ADDENDUM NO. 1
PACIFIC HWY NON-MOTORIZED
CORRIDOR PHASE 1 – S 304TH ST TO
DASH POINT RD
RFB# 24-011
PROJECT #36219
FEDERAL AID #SRTS-0099(154)
June 13, 2024

ATTENTION ALL BIDDERS AND PLANHOLDERS: You are hereby notified that the Bid and Contract Documents are amended as follows:

PACIFIC HWY S NON-MOTORIZED CORRIDOR
PHASE 1 - 16TH AVE S (S 304TH ST TO S DASH POINT RD)

DRAINAGE PLANS AND PROFILES

SHT. 41
OF 79
CITY PROJECT #:
36219

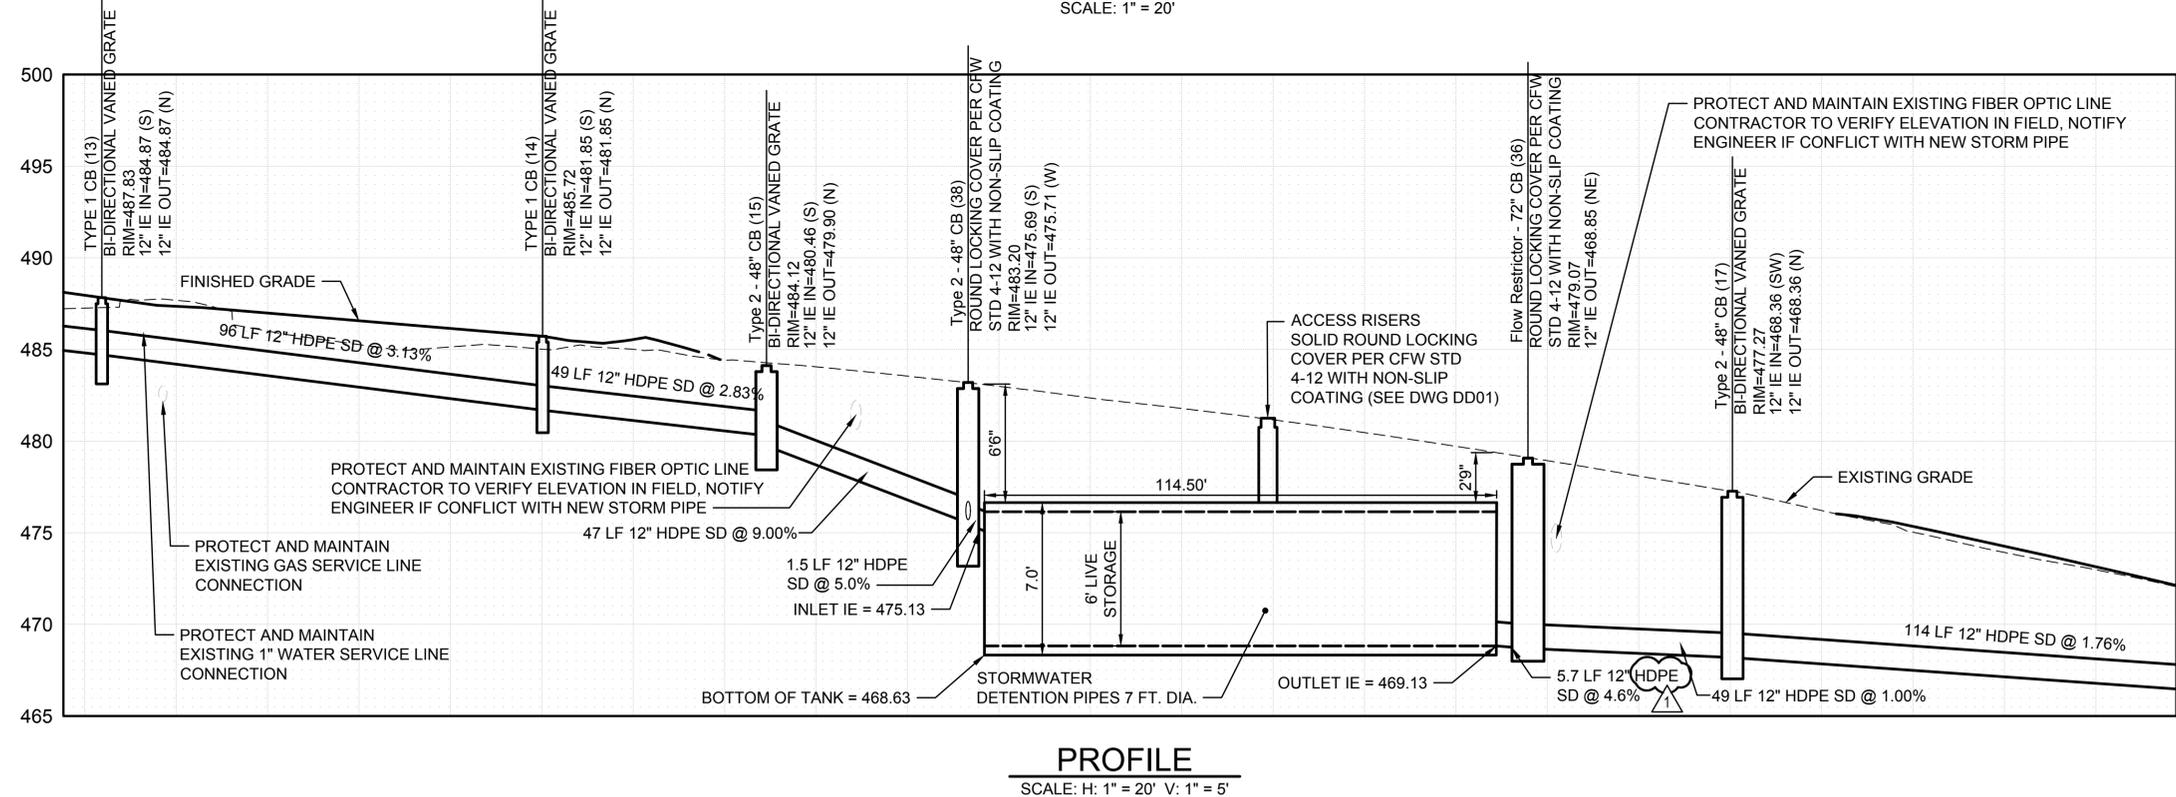
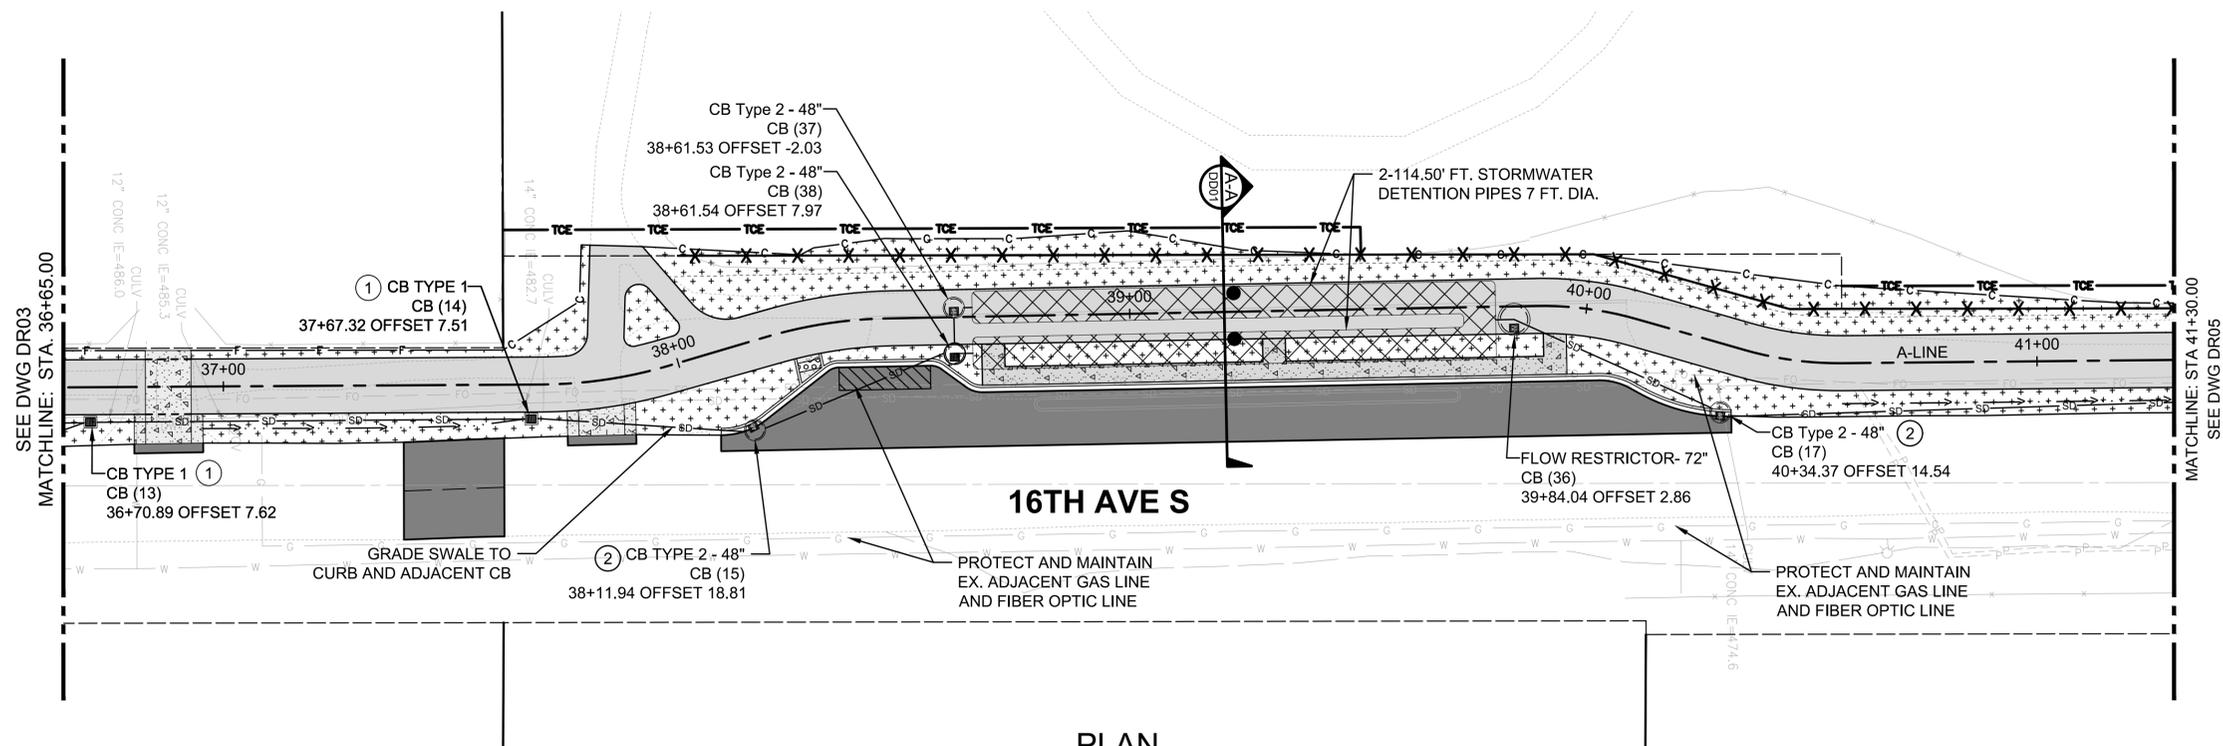
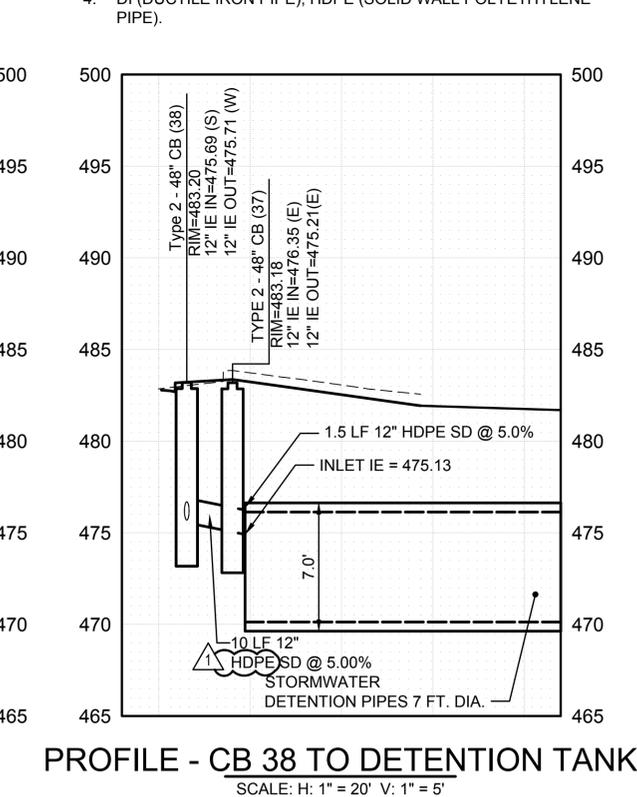
Replace sheet 41 with the attached revised sheet 41. Changed the material callout for two pipes from CPEP to HDPE.

DRAWING VERSION / REVISION LOG		
NO.	DATE	REVISION
1	06/05/24	CHANGED SD PIPE LABELS TO HDPE
